File FPP-1996-246

Name: Moonrise East Sanitary Sewer Air Test – Final Plat Plan – Moonrise East/Sunset Village-NE Corner 25.5 & F.75 Roads  
No Regular Development File – this scan is from the Engineering File

RE: Moonrise East Subdivision – Project closeout

Moonrise East Subdivision, As-Builts and Request for a Final Walk Through Inspection

OUTLET STRUCTURE NOT TO SCALE

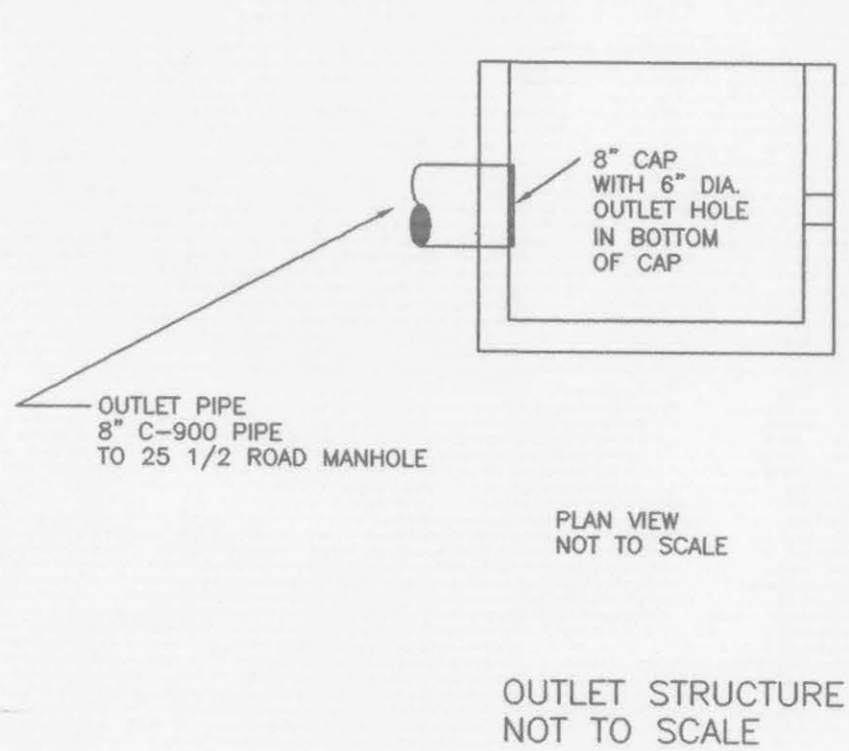
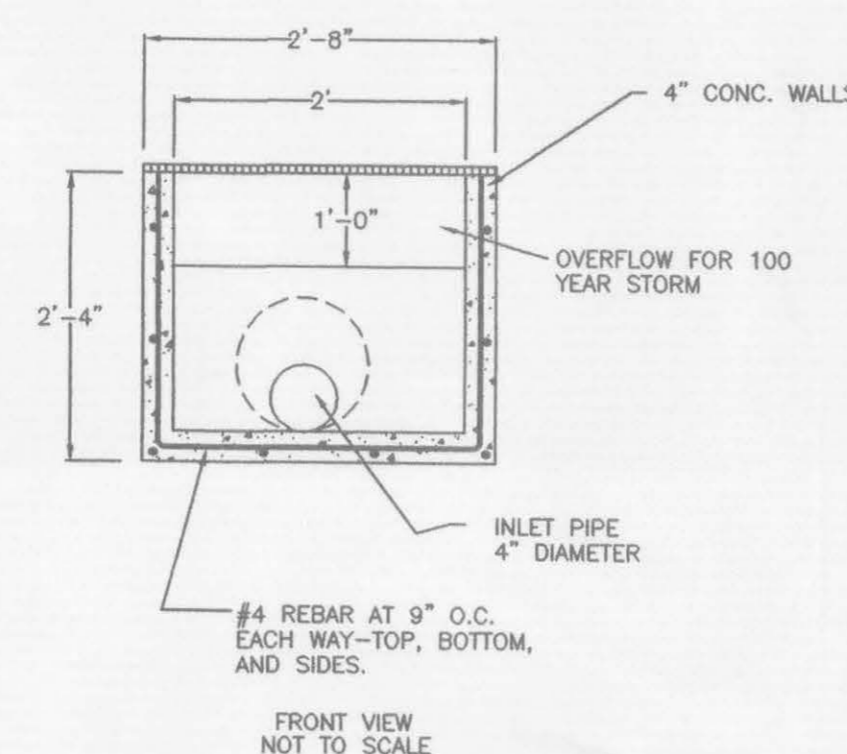
1. The top of the outlet structure does not have a grate. A grate that is attached with galvanized bolts must be installed. Other items may be incomplete, please make sure all construction as shown on the approved construction drawings and specifications has been completed prior to scheduling the final "walk-through" inspection.

1. A grate has been installed on top of the outlet structure.
2. The Owner has opted to place cobble in the bottom of the detention basin.
3. The grading for the ditch through the Moran property has been graded for a positive flow with a minimum of 2:1 sideslopes to an inlet on the East side of 25 1/2 Road-see below.
4. A inlet box has with a grate on top has been installed to discharge water into the 12" irrigation/drainage pipe in 25 1/2 Road.

The outlet structure was set higher than the grades called for on the plans so in order to maintain the required volume requirements, the detention basin grading was raised to reflect that change in grade in order to maintain the required volume.

REVISED 9/4/00 TO SHOW AS-BUILTS  
GRADING AND DRAINAGE PLAN

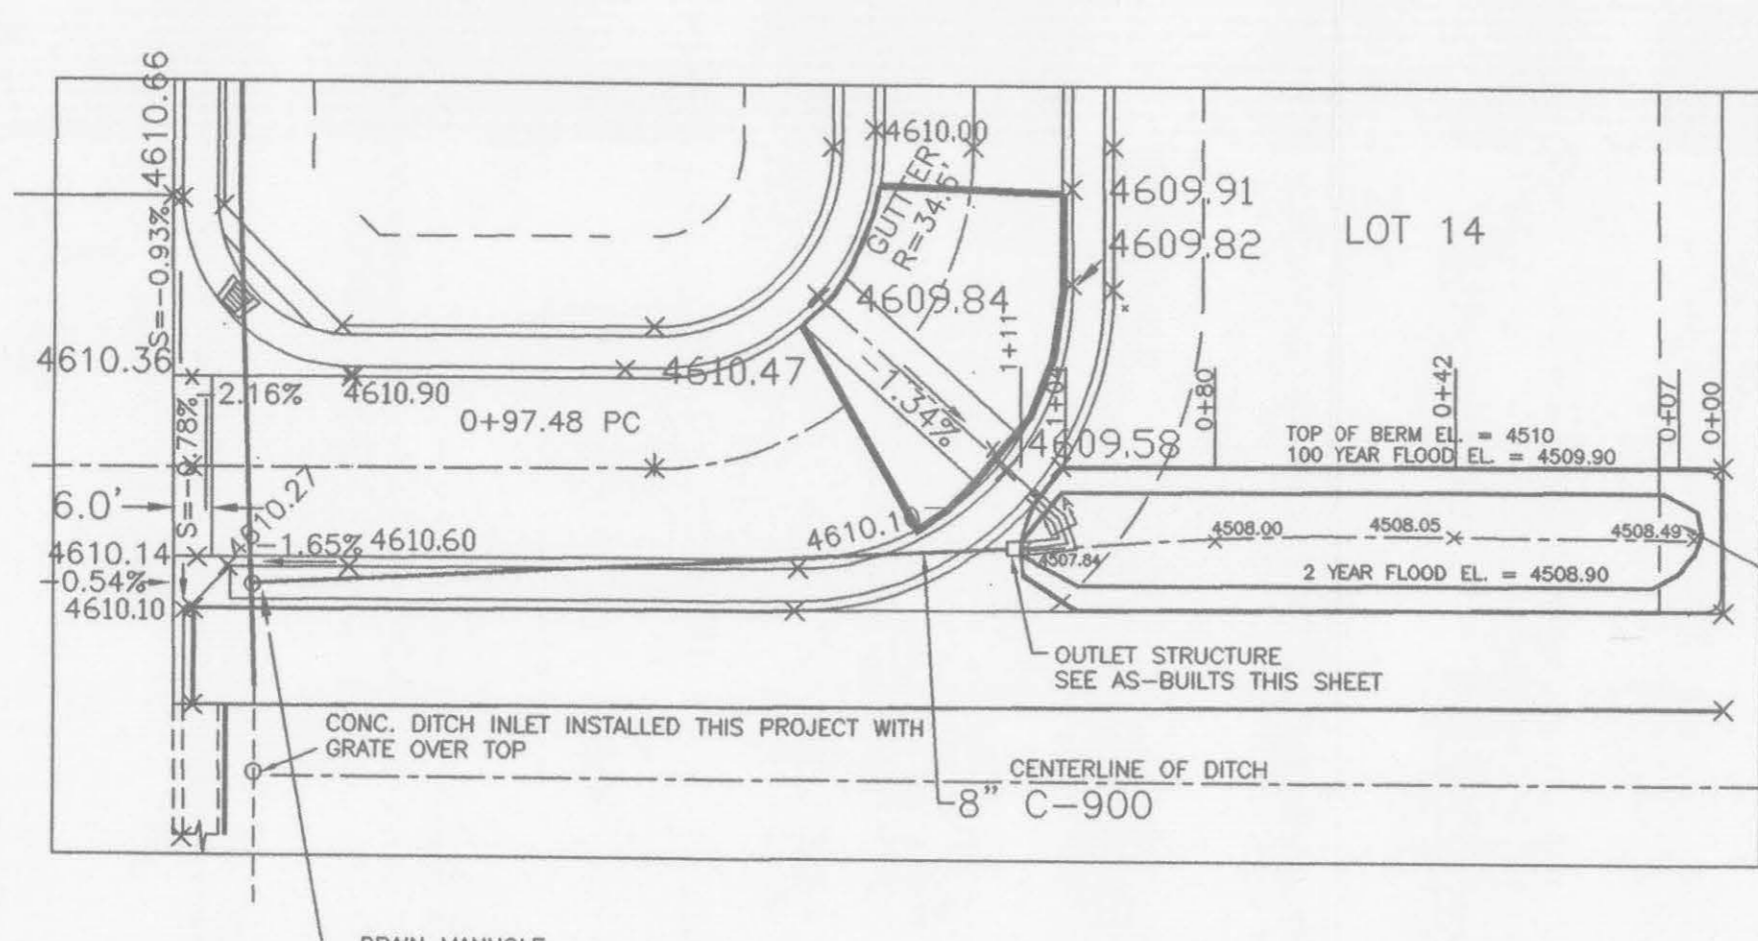
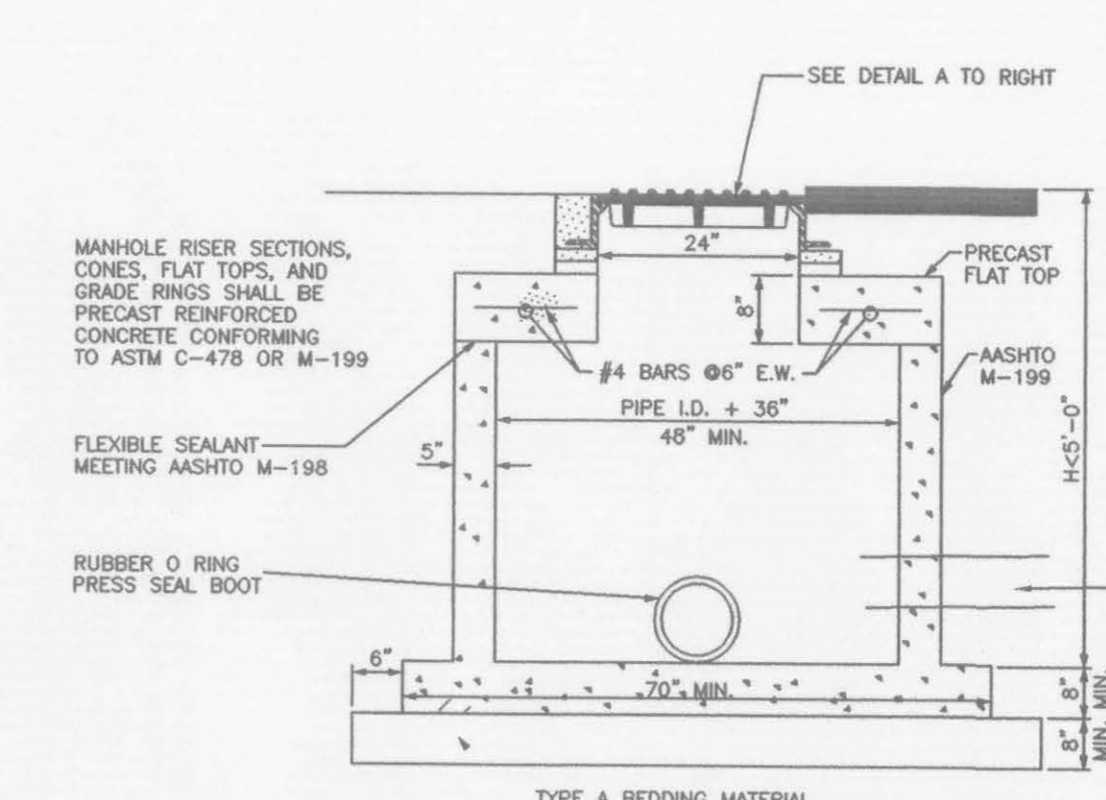
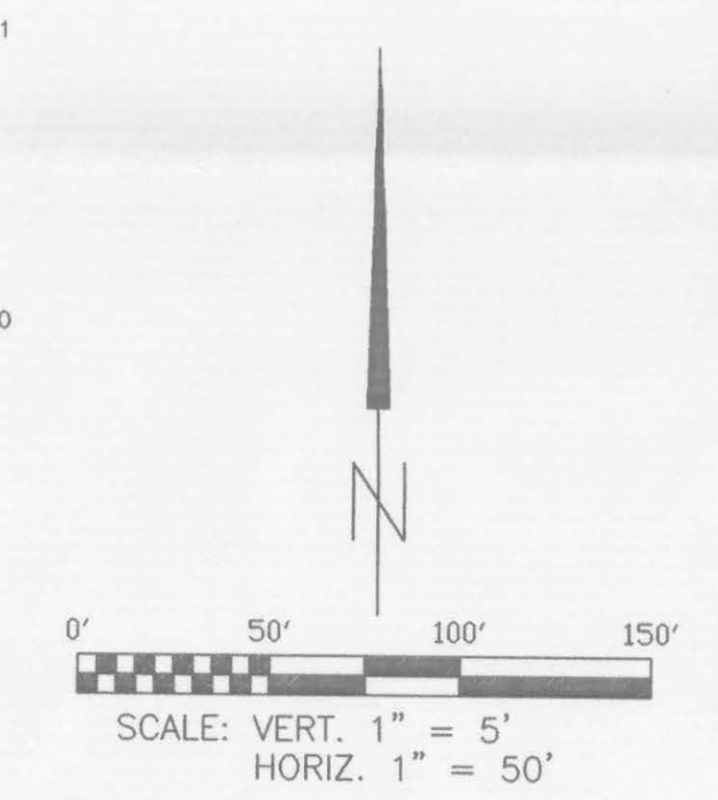
2. The bottom of the detention pond has a relatively flat grade (<0.5%). The Stormwater Management Manual requires a concrete valley pan in the bottom of the pond when flowline grades are less than 2%. This requirement was not enforced as a condition of final approval for this project. However, it is recommended that a valley pan be installed so that nuisance flows do not cause ponding in the bottom of the pond, and so that maintenance of the pond area may be simplified.

3. The drainage ditch installed on the south side of the detention pond to drain the Moran property appears to be incomplete. Please verify that the flowline of the drainage ditch is constructed with a consistent grade toward 25 ½ Road. Also, the sides of the ditch should be laid back to a minimum slope of 2 horizontal to 1 vertical.

4. The 12" irrigation / drainage pipe running along the east side of 25 ½ Road is the only outfall available for the Moran drainage ditch. Please install an inlet box with area-type drain grate, or grated pipe stub over the irrigation / drainage pipe at the end of the Moran drainage ditch.
